THE SHERWIN-WILLIAMS COMPANY
Environmental, Health & Regulatory Services
101 Prospect Avenue NW
Cleveland, Ohio 44115-1075
Facsimile: (216) 566-2730

RE: Sherwin-Williams/Hilliards Creek Site- Former Manufacturing Plant
Gibbsboro, New Jersey
Administrative Order Index No. II CERCLA-02-99-2035

Response to USEPA and NJDEP May 2, 2012 Comments on
January 20, 2012 *Revised Work Plan for Additional
Groundwater Characterization*

Piezocone: 20 TON AD204
Date: 05:02:07 13:29

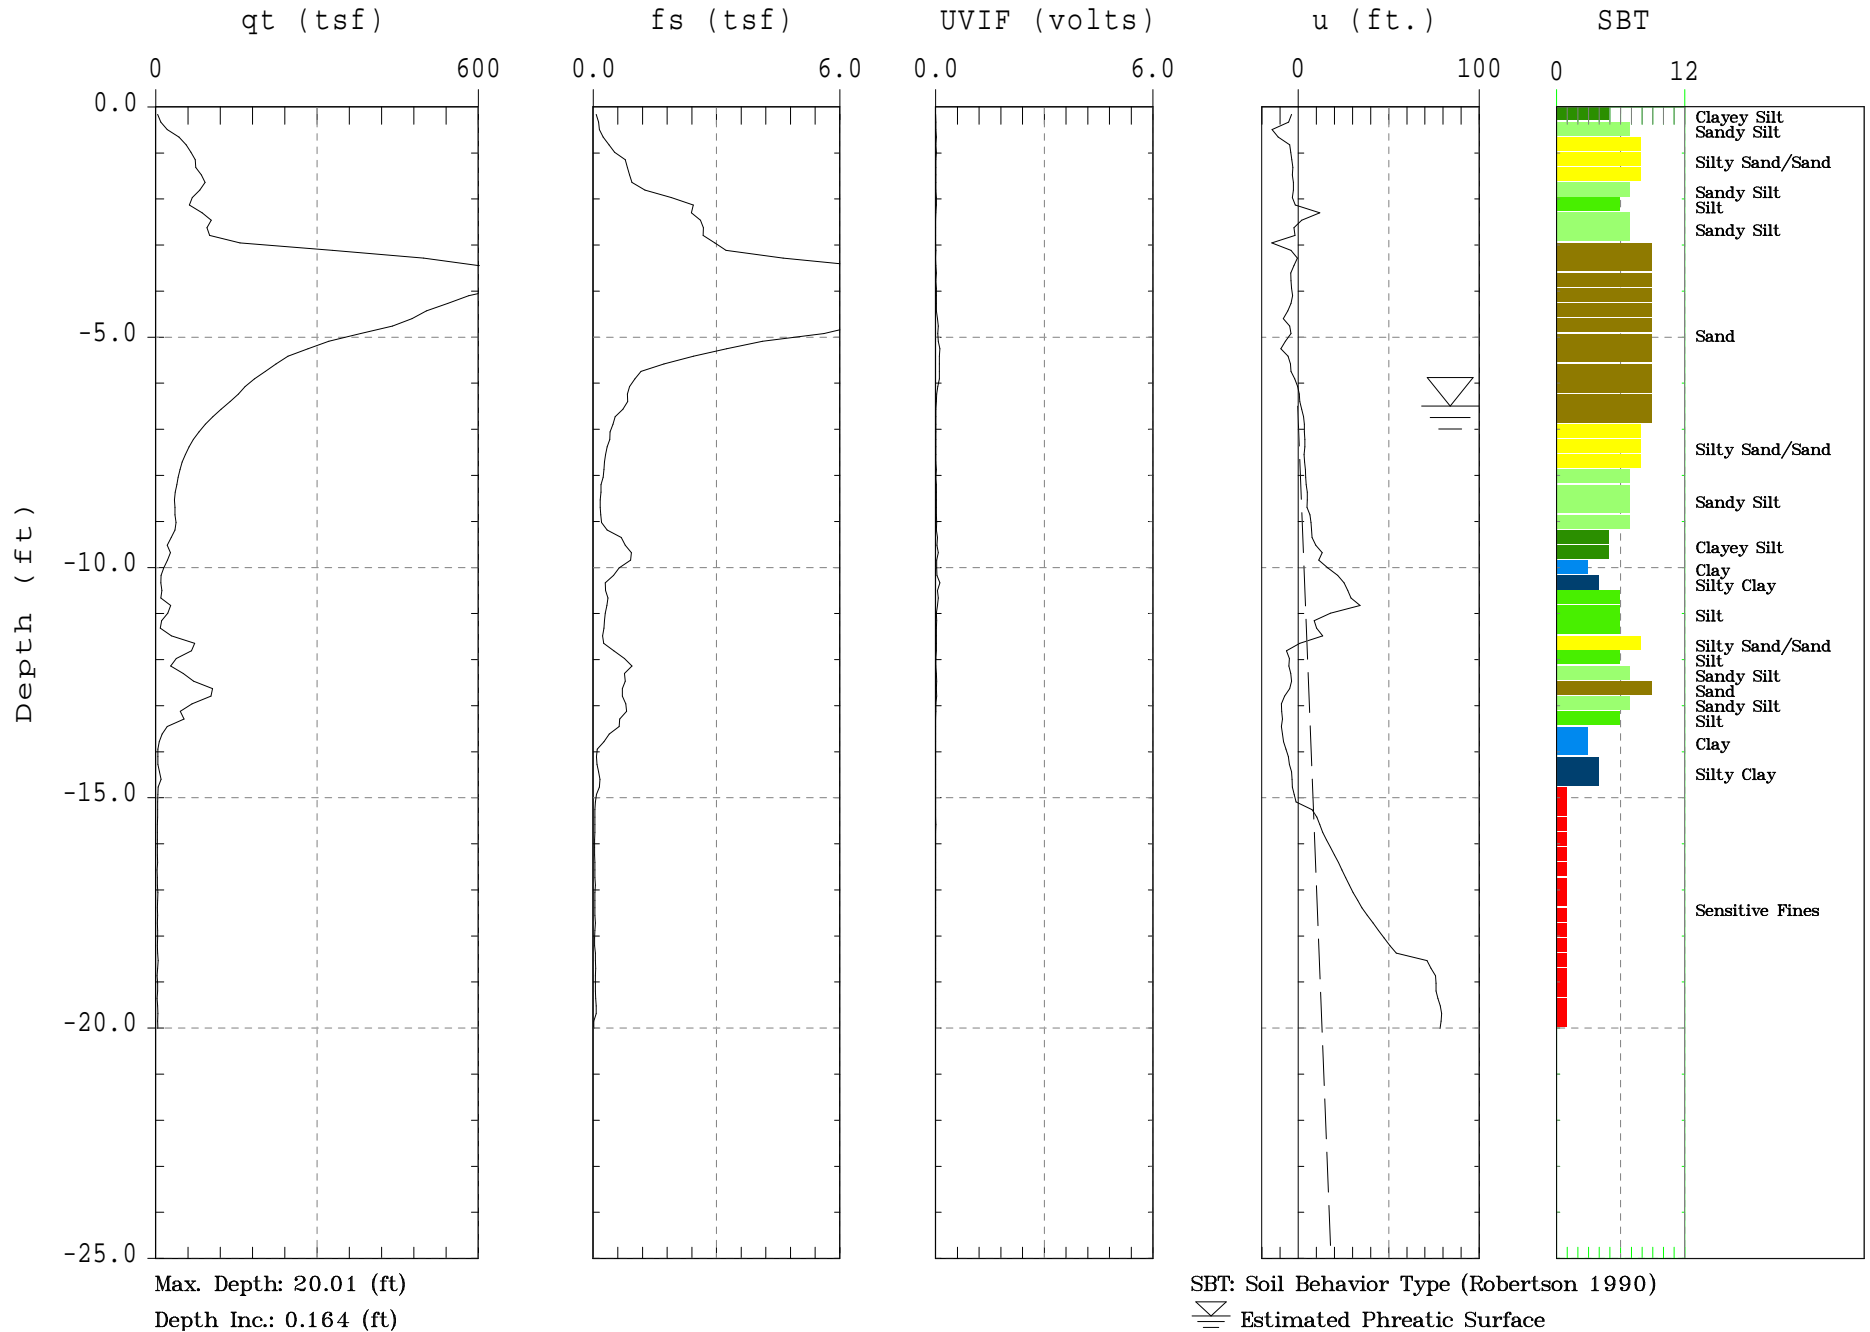
In the other UVIF/LIF log (CPT-13), no real UVIF response was observed. In this case, it may be that the sensitivity was not great enough to detect any petroleum that may be present (the response was set at 6 volts) or there may not have been any significant amount of petroleum in the boring.

Sounding: CPT-01
Site: Bridgeport, NJ

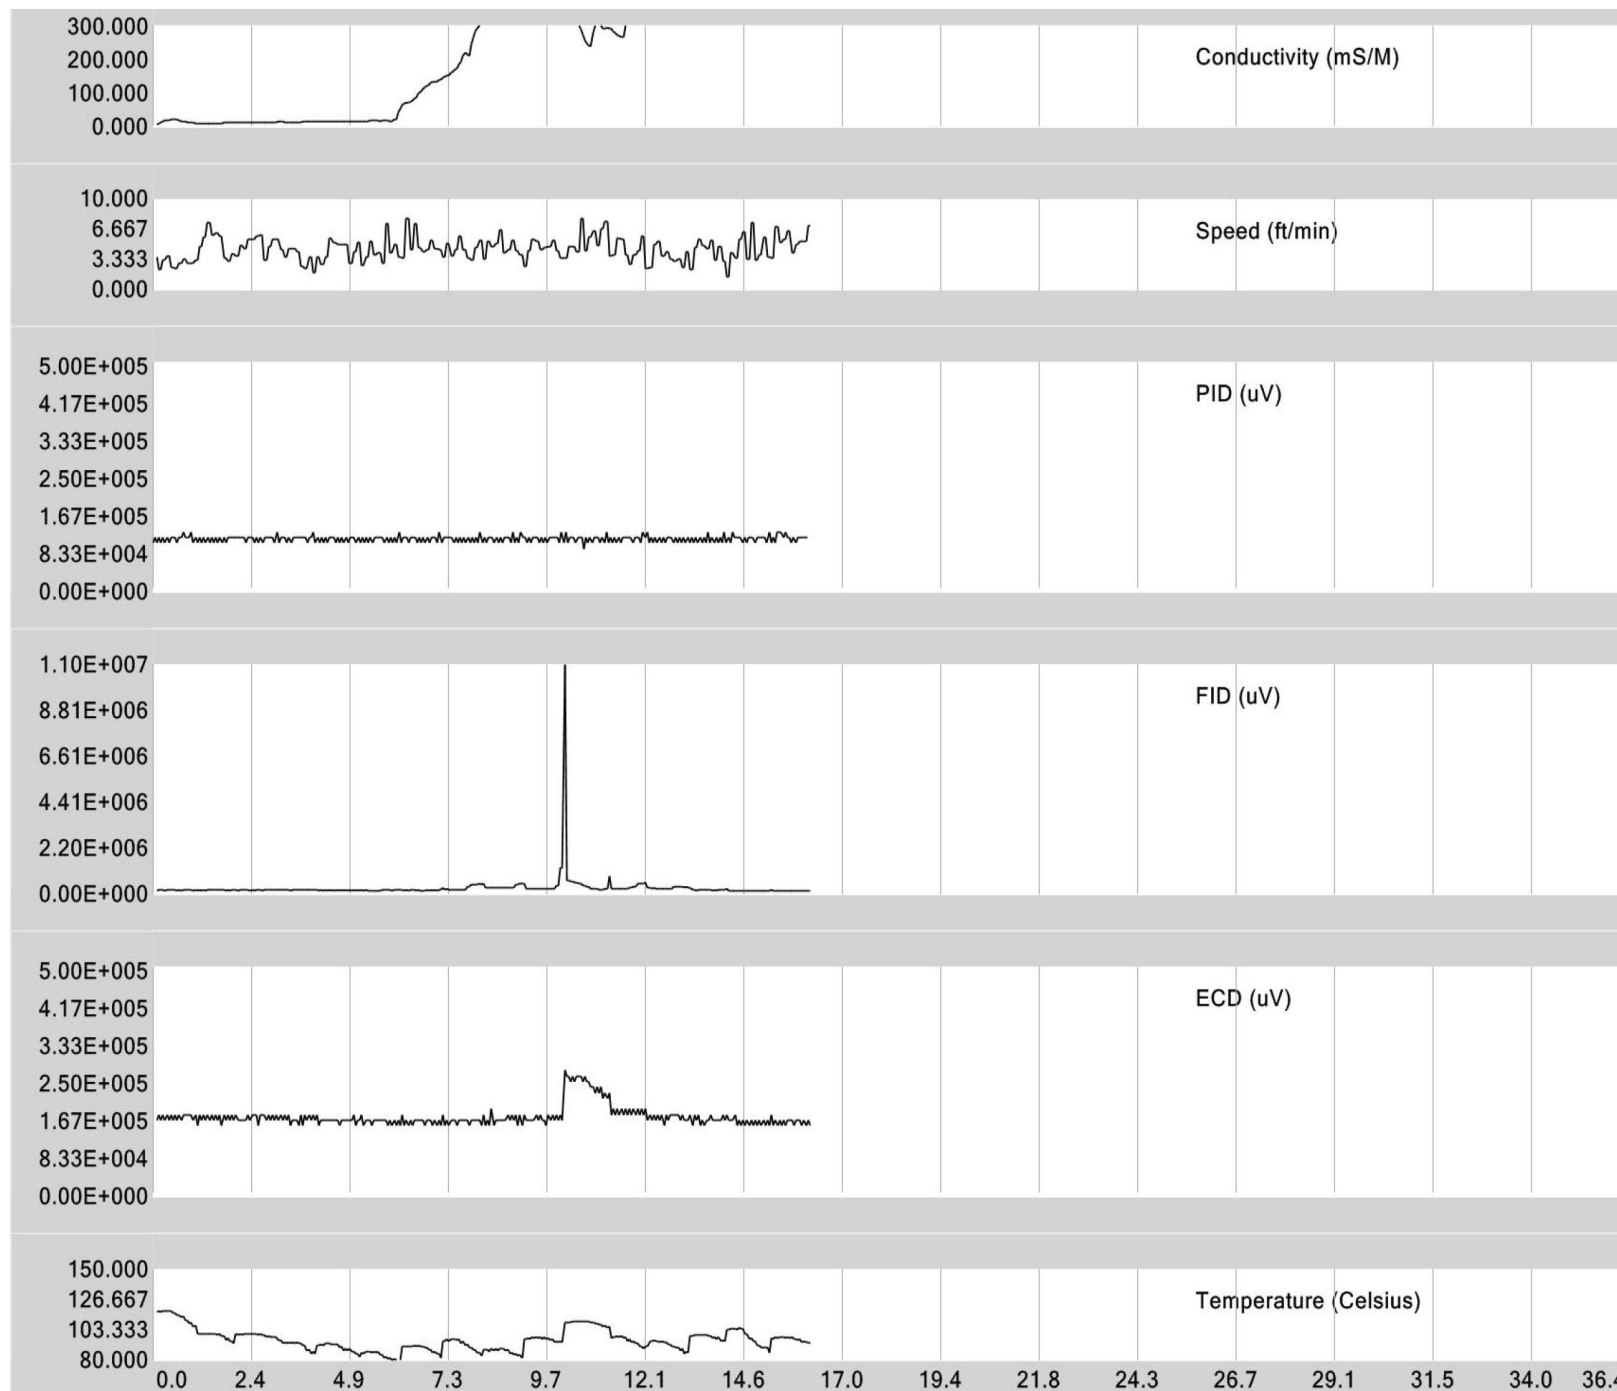
As shown on the log where a response was observed (CPT 01), the response began at a depth of approximately 7 feet, or immediately below the water table, and extended to approximately 14 feet. The soils in which the response was observed were determined to be sands based on the cone penetrometer data.
